## **Proposal for Supplement 4 to the 03 series of amendments to UN Regulation No. 129 (Enhanced Child Restraint Systems)**

### **Submitted by the expert from CLEPA\***

The text reproduced below was prepared by the experts from the European Association of Automotive Suppliers (CLEPA) to improve the reproducibility of dimensional measurement assessments.

Figure [x] Example of a simplified ISO R2 fixture with the sliding element of component 1 highlighted on the right in open and closed position, and the support leg volume and the support leg foot volume.

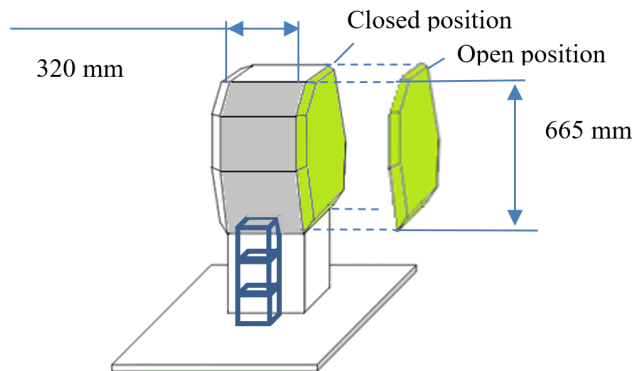
**Sliding element of component 1:**

It shall be possible to slide one side element of the CRF, including its chamfers, over at least 200mm in the Y direction. In the closed position it reaches the correct size of the relevant CRF. In the open position the sliding element is moved outwards from the relevant CRF position by 200 mm or more.

The sliding side element is defined as follows: all surfaces are visible when looking towards the CRF along the Y axis of the ISOFIX anchorages as defined in Para 6.3.5. and shown in the figures in R16, Annex17, Appendix 2.

To verify the measurement equipment strength, a force of 135 N -0/+15N shall be applied in the centre of each individual surface of the fixture.

Deformation shall not be greater than 2mm +/- 1mm
